Public Meeting Summary

Permanent Canal Closures & Pumps March 24, 2010

Permanent Canal Closures & Pumps

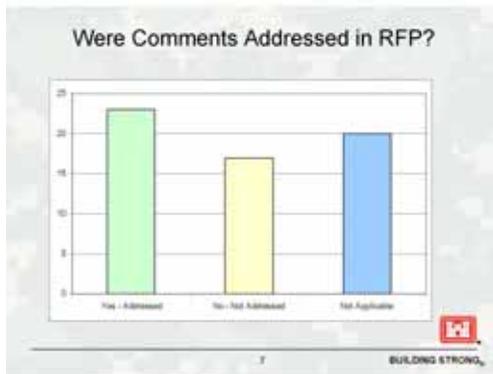
This slide up here illustrates the subjects of the comments received during the RFP comment period and they range from acquisition to aesthetics, breakwaters, O&M, Option 2 and 2A, as we know that not authorized but we still have the comments there help prod the RFP, public design review, pump types, risk, traffic and aesthetics, which seem to be especially important.

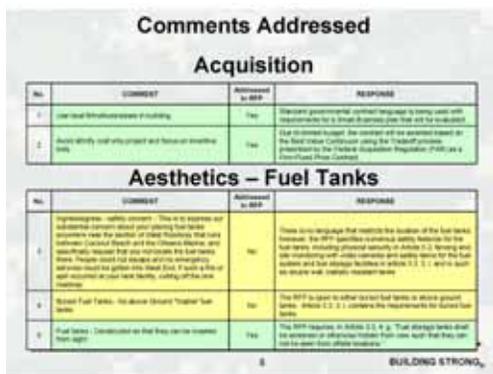
The next slide will illustrate the number of comments that were addressed in the RFP, the number of comments there were not addressed and it's not a definite no, it's probably in there or addressed in a different document and then those that didn't apply – things that have to do with something other than the authorized project.
